HYDROLOGY L15/D11 ONE PLAN

1902 & 1906 Buena Vista S.E

1902, 1906 Buena Vista SE 9-30-80

RETAINING WALL DETAIL

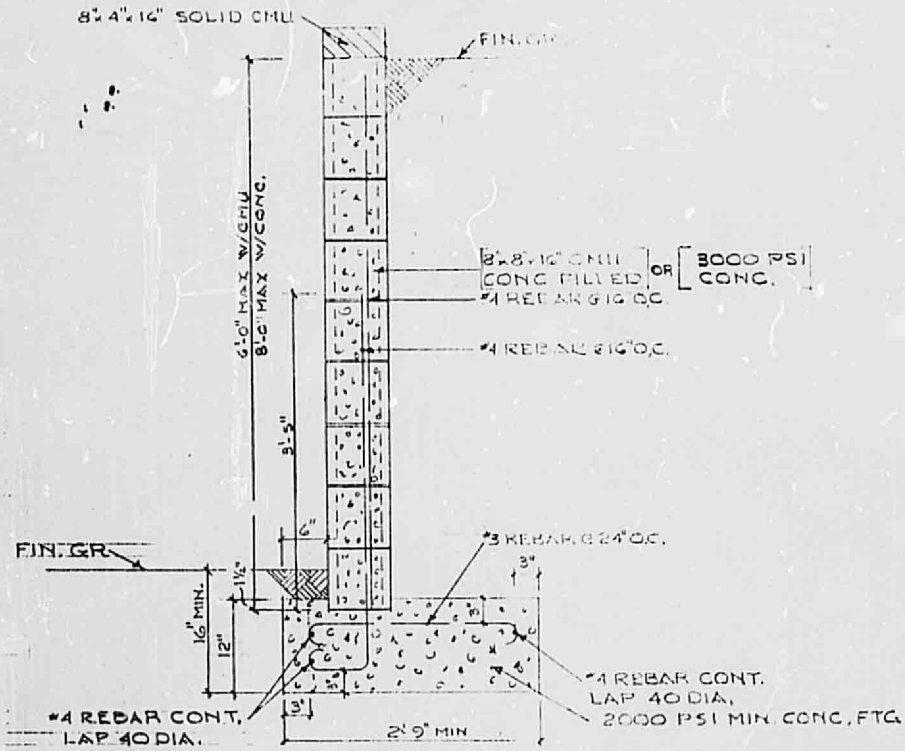
Design checked and found satisfactory. Specific application of this design not considered.
